**RANDOX**  
**Urgent Field Safety Notice**

**Complaint Reference:** REC687

**Action Type:** Device Modification

Randox are currently investigating RX Parameter rerun settings (Sample Volume Low/High), and Dilutions used for Auto reruns on the following analysers RX Daytona Plus (with ISE), RX Daytona Plus (without ISE), RX Imola, RX Modena and (Sample Volume Decrement/Increment), on the RX Monaco analyser.

Rx Daytona Plus:

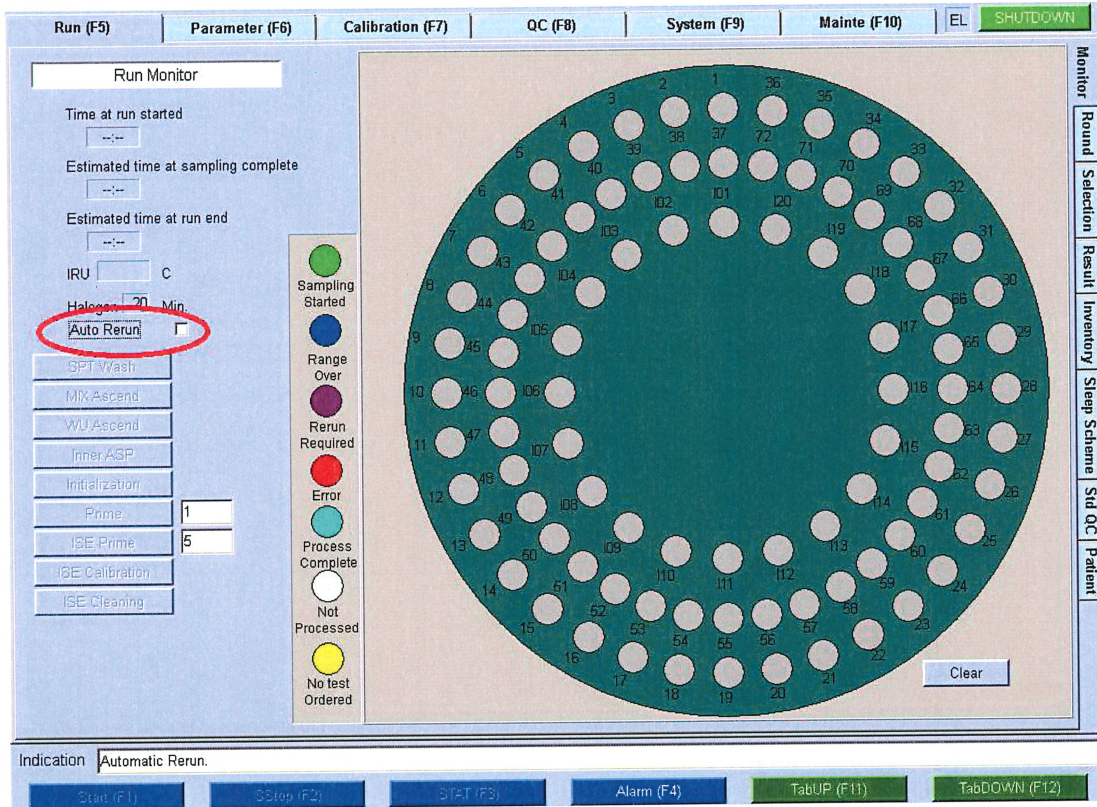
Ensure this box is unticked.

Rx Imola:

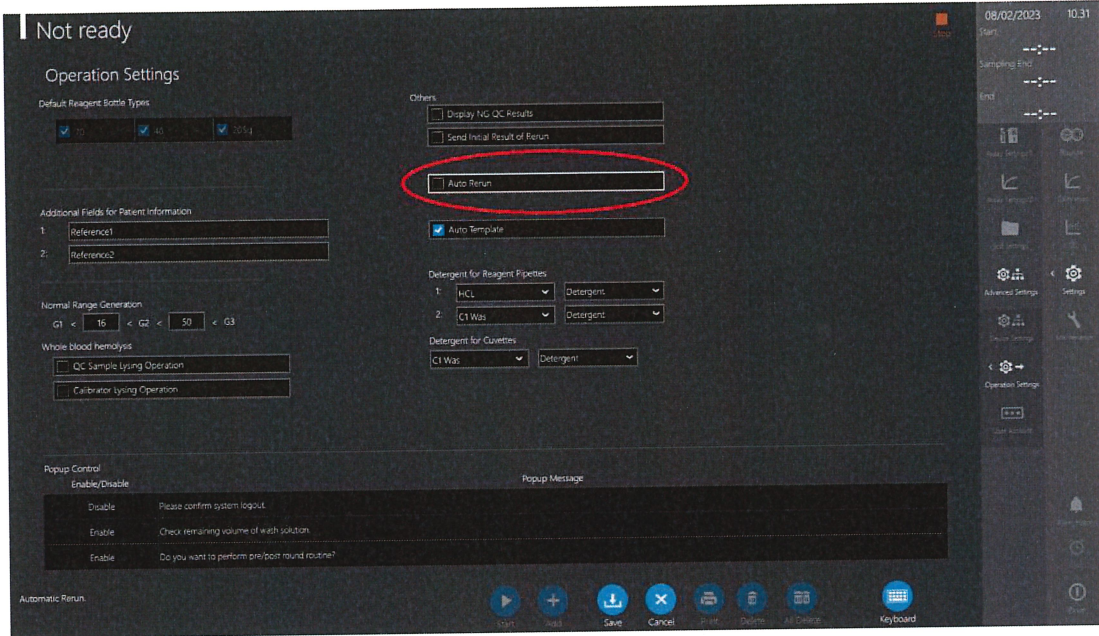
Ensure this box is unticked.
